ADDENDUM NO. 3

POLYTECH HIGH SCHOOL
RENOVATIONS AND ADDITIONS
BID PACKAGE 'B'

This addendum is hereby made part of the Project Manual and Drawings dated 9 November 2012.

PA1.2

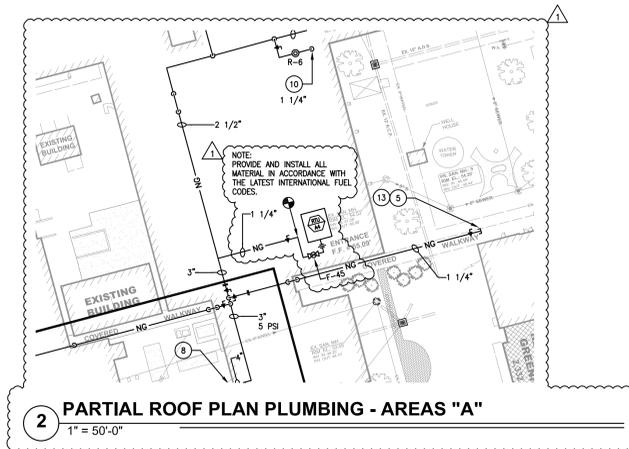
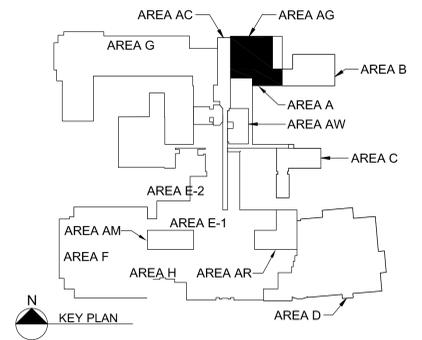
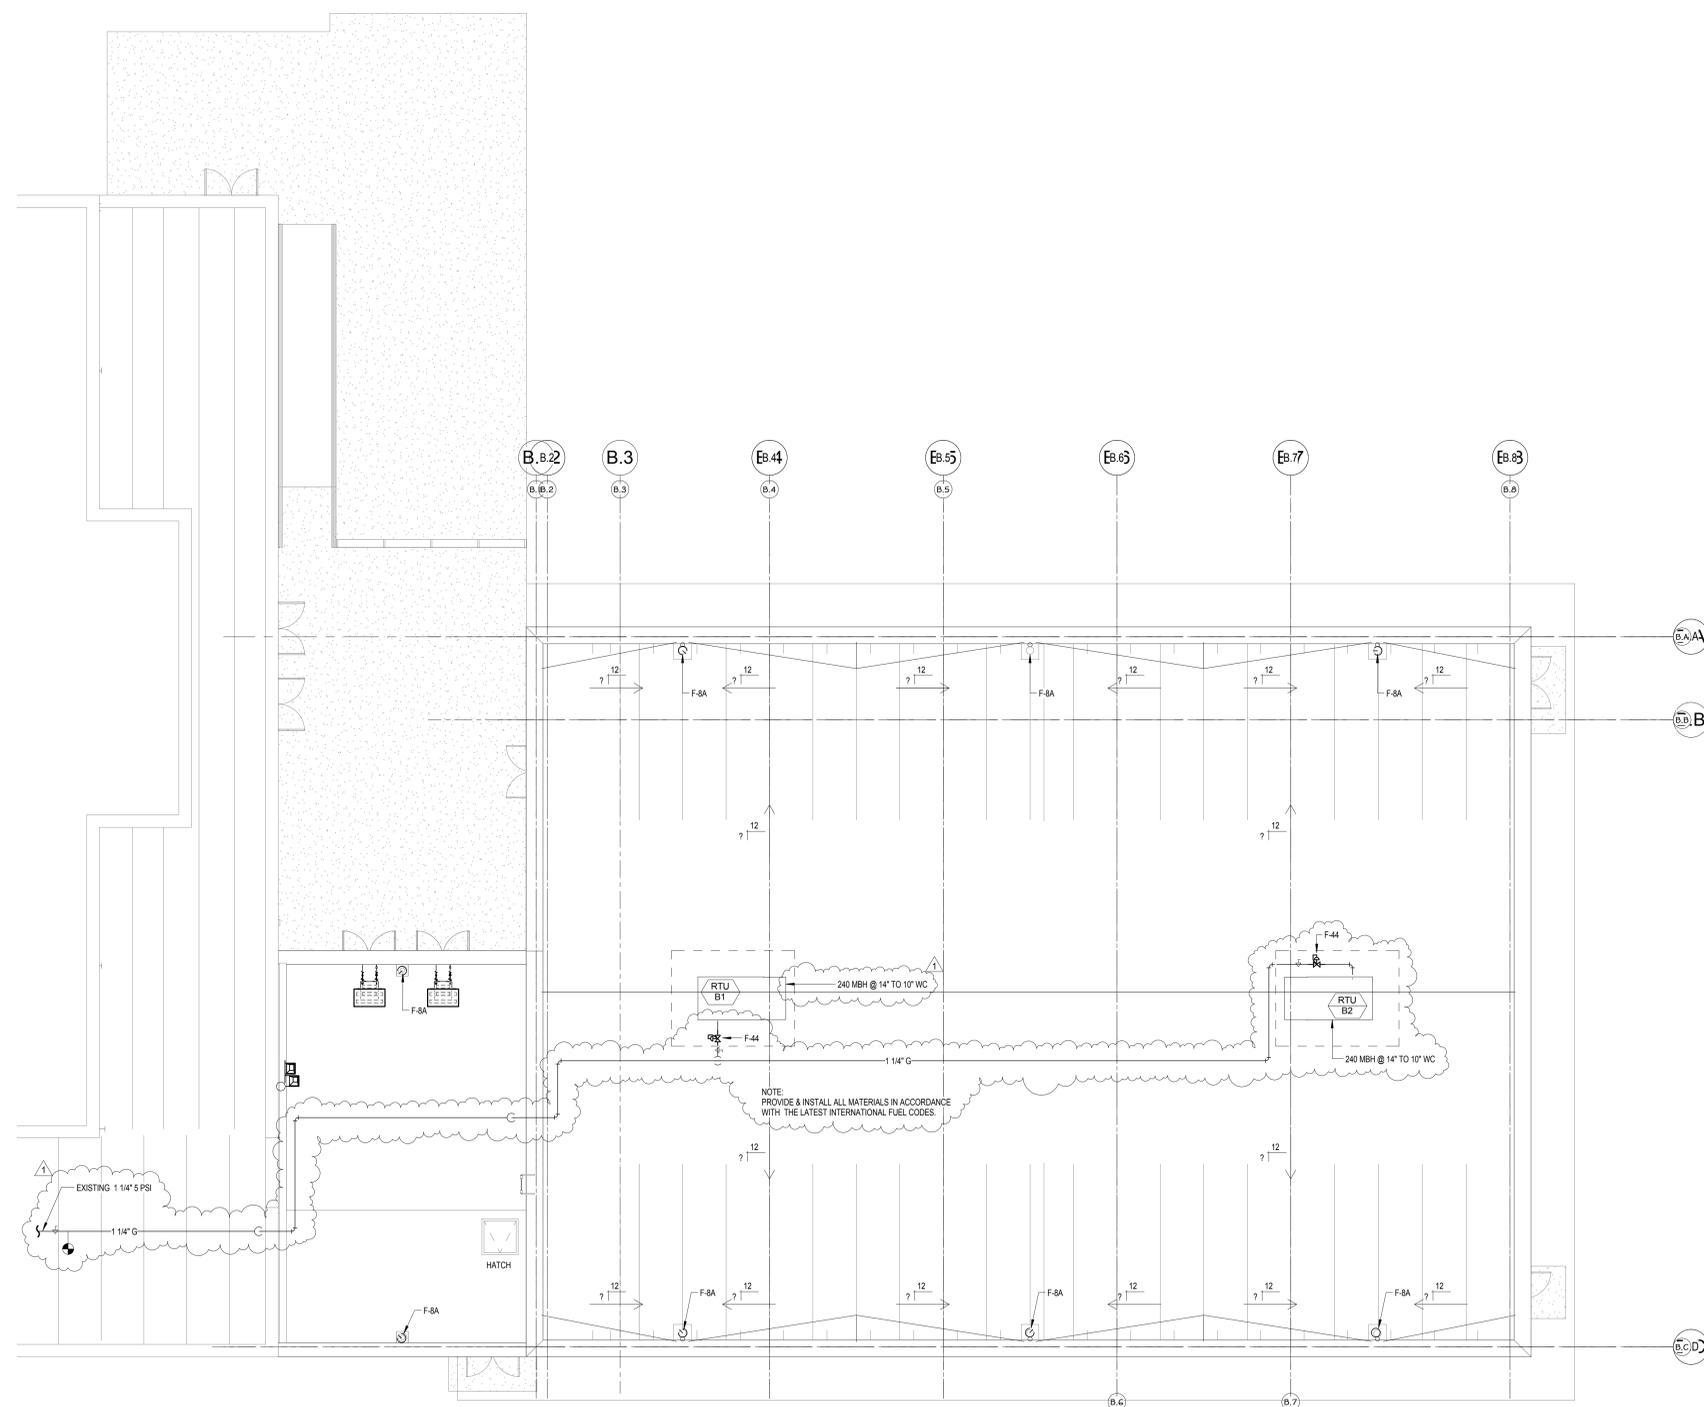
1. Add Partial Roof Plan. See revised Drawing PA1.2.
2. Add F-45 Gas Pressure Regulator to RTU-A4. See revised Drawing PA1.2.

PC1.1

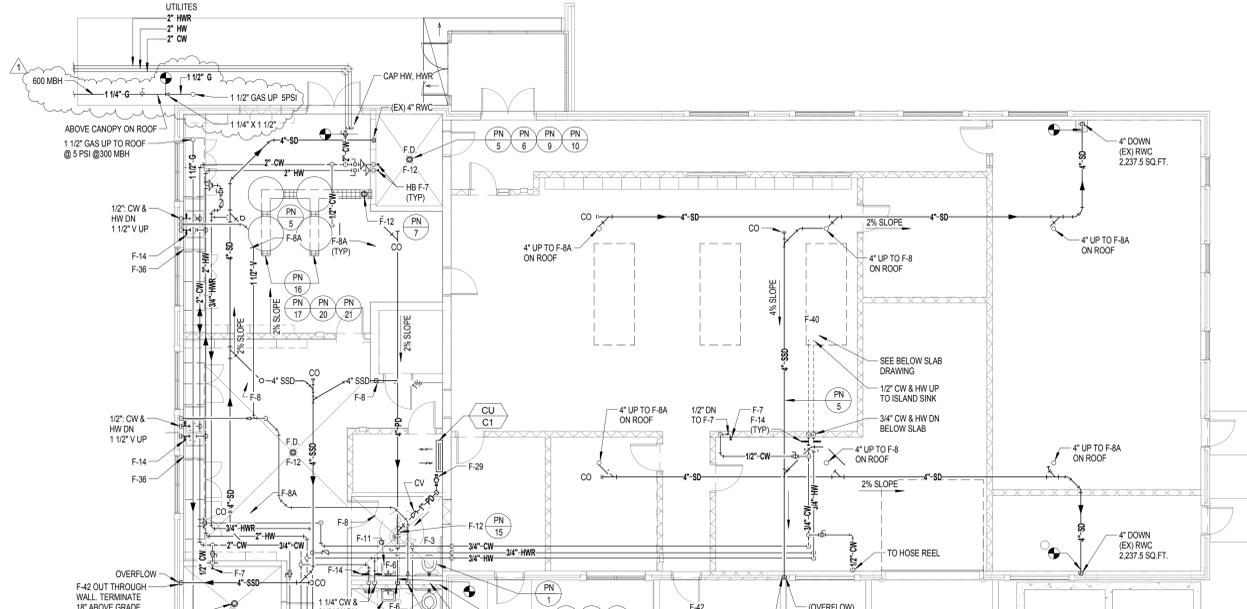
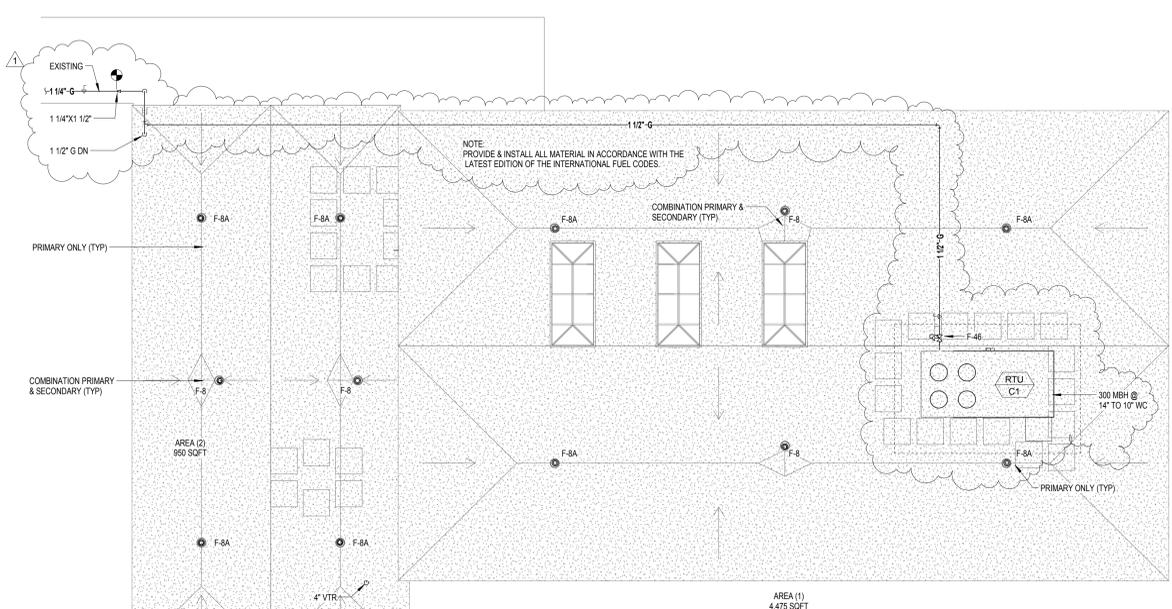
1. Add tie in to 1-1/4" gas pipe. See revised Drawing PC1.1.
 2. Add Rooftop Gas Piping to RTU-C1. See revised Drawing PC1.1.
 3. Add F-46 Gas Pressure Regulator. See revised Drawing PC1.1.

4. Add Note. See revised Drawing PC1.1.
 5. Add Gas Shut off valves. See revised Drawing PC1.1.
 6. Revise Note 16. See revised Drawing PC1.1.
- D. Drawing PD2.1, "PLUMBING PLAN AREA 'B'"

PD2.1

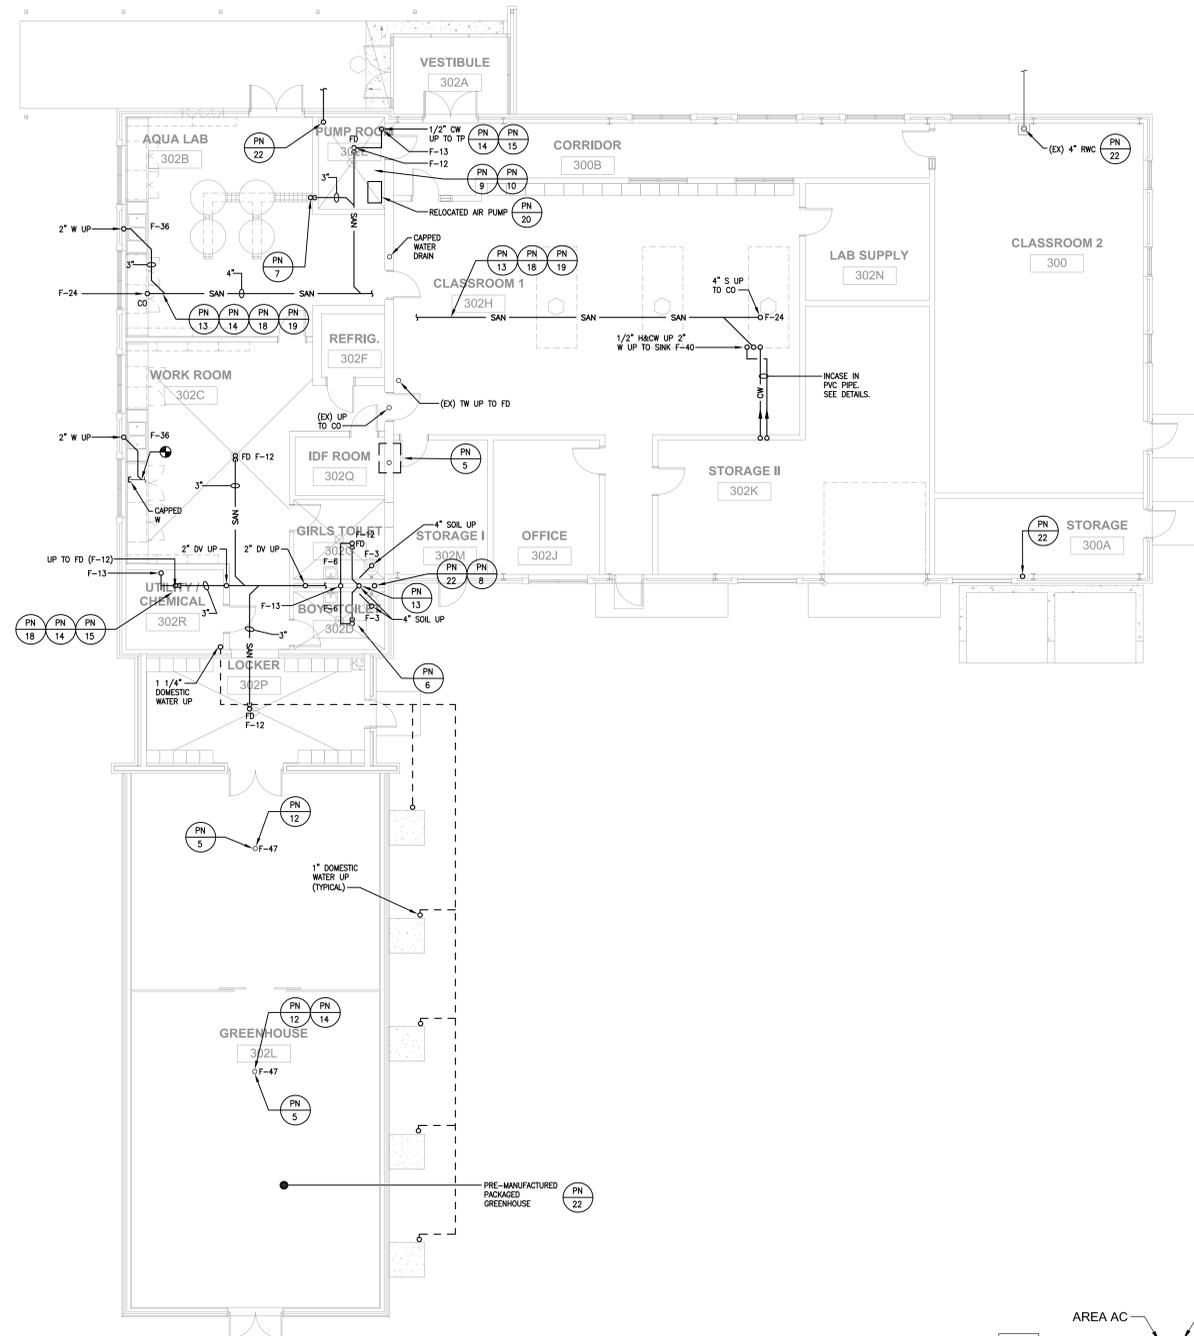
1. Add tie in to 1-1/4" gas pipe. See revised Drawing PD2.1.
 2. Add Roof Top Gas Piping. See revised Drawing PD2.1.
 3. Add notes. See revised Drawing PD2.1.

4. Add Gas Shut-off valve. See revised Drawing PD2.1.
- E. Drawing PUC1.1, "ENVIRONMENTAL SCIENCE BELOW SLAB PLUMBING"
1. Revise Note 16. See revised Drawing PUC1.1.

DEA1.3

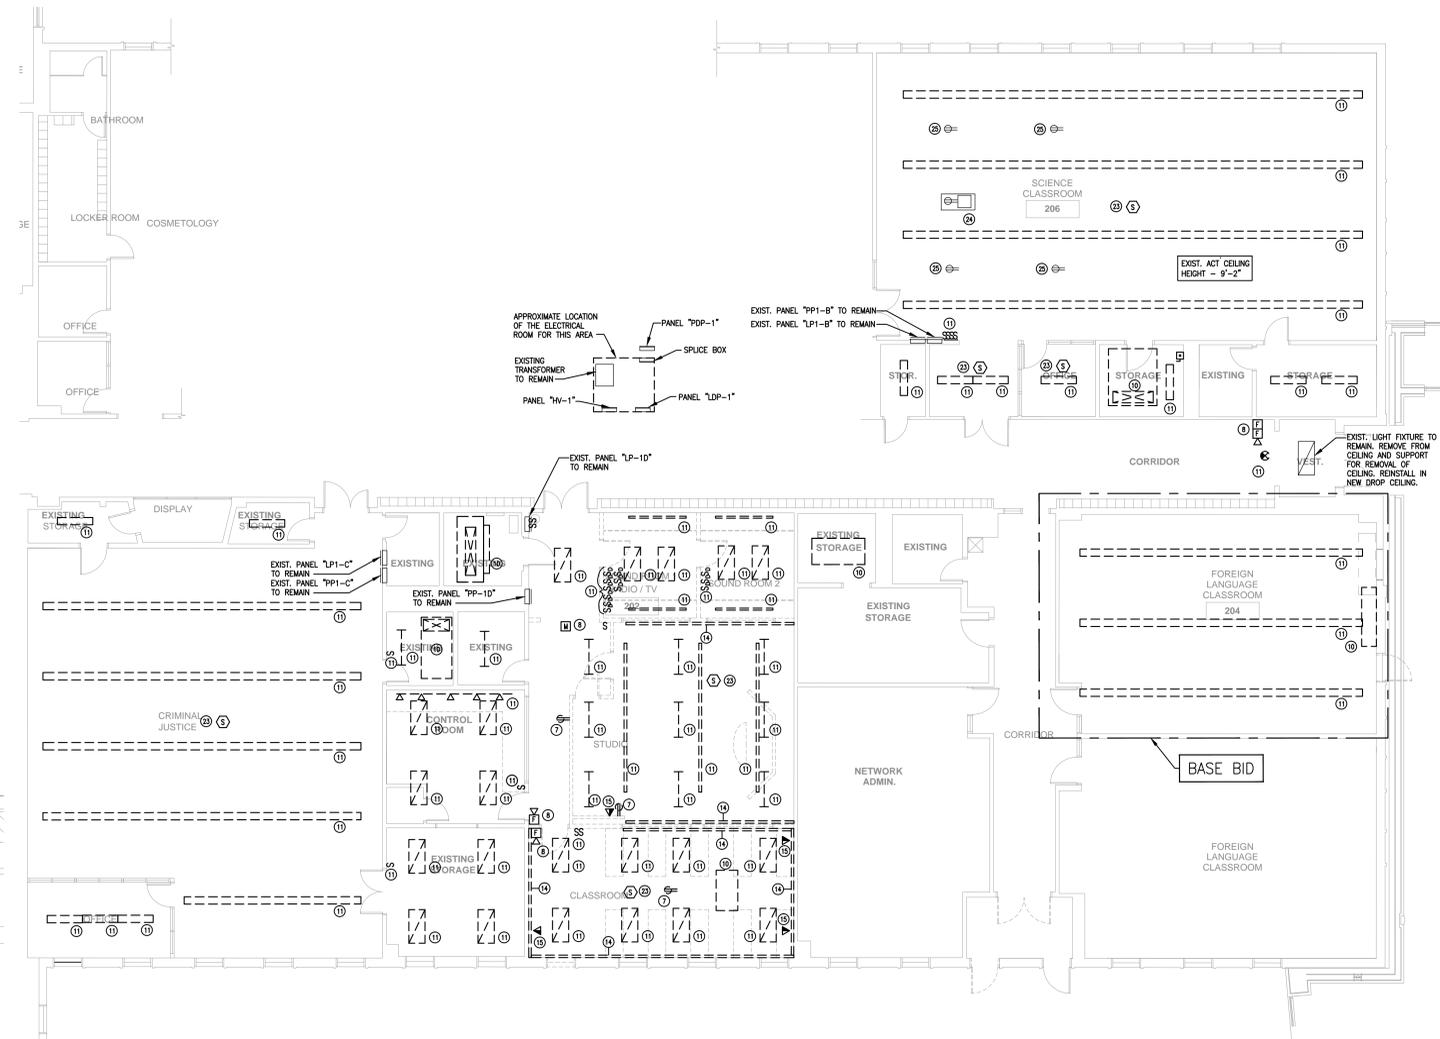
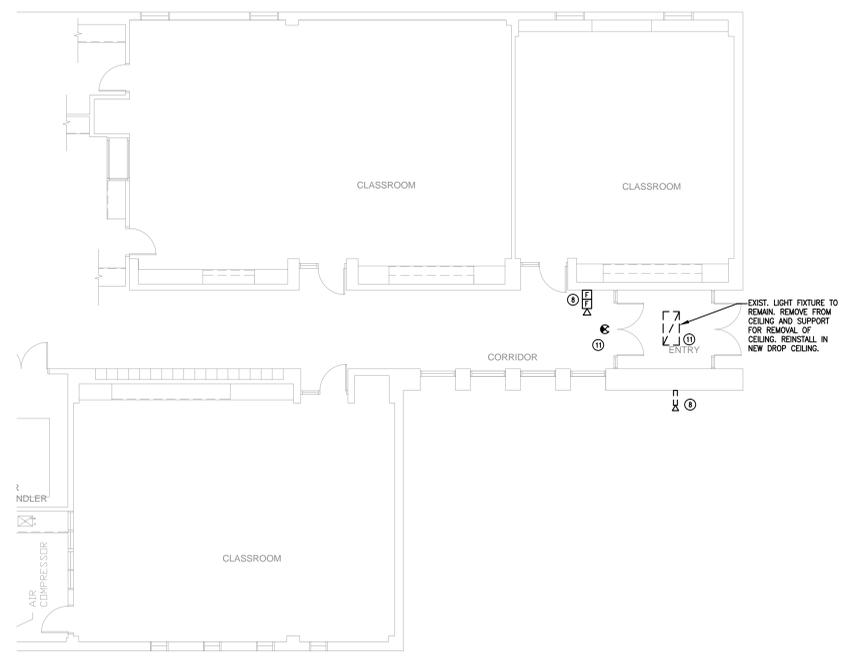
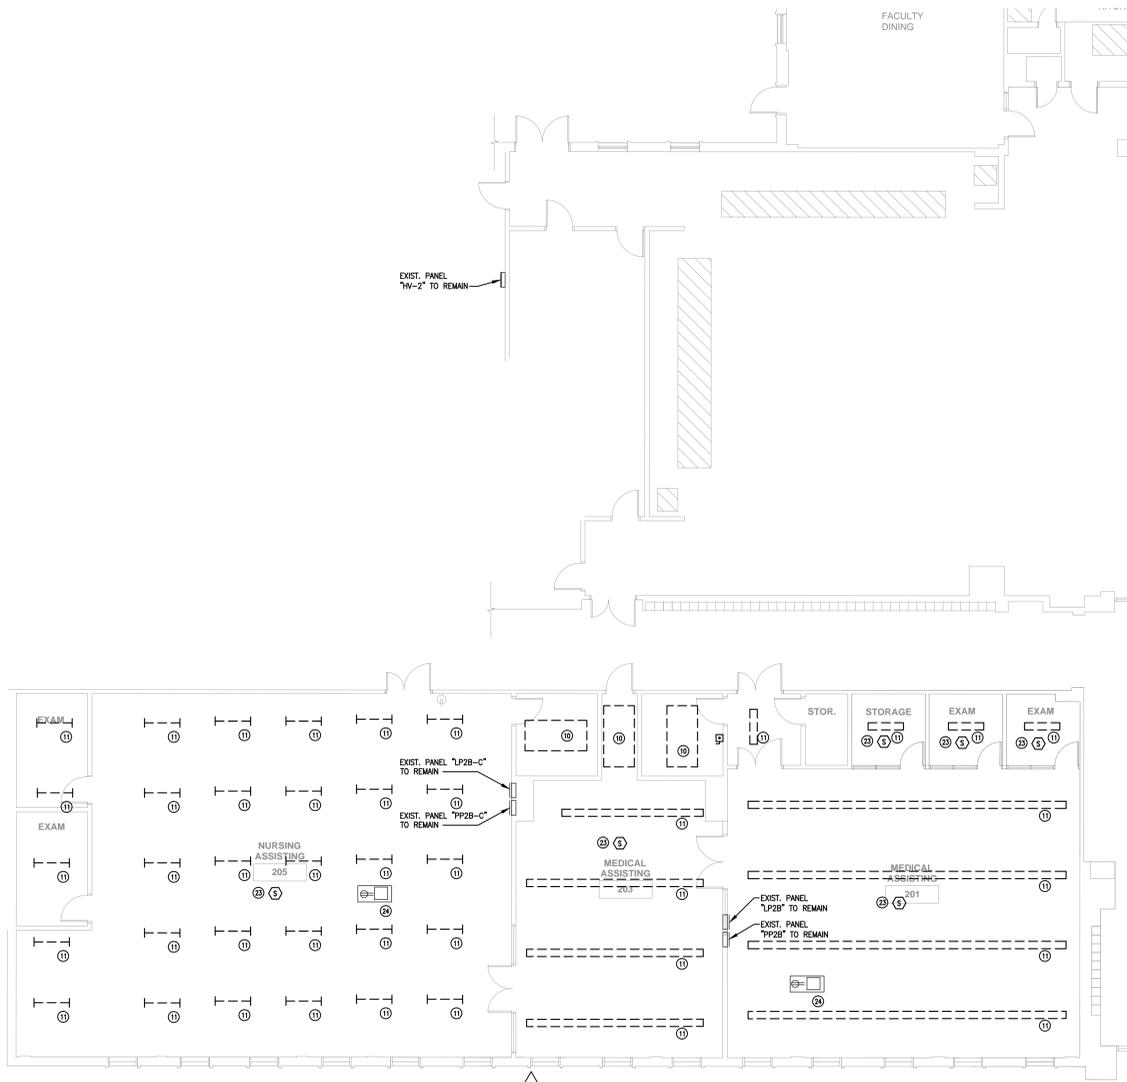
1. Revise Fire Alarm Devices and notes. See revised Drawing DEA1.3.
- M. Drawing EA1.1, "EXIST. CORRIDOR ELECTRICAL"
1. Revise Fire Alarm Devices and notes. See revised Drawing EA1.1.
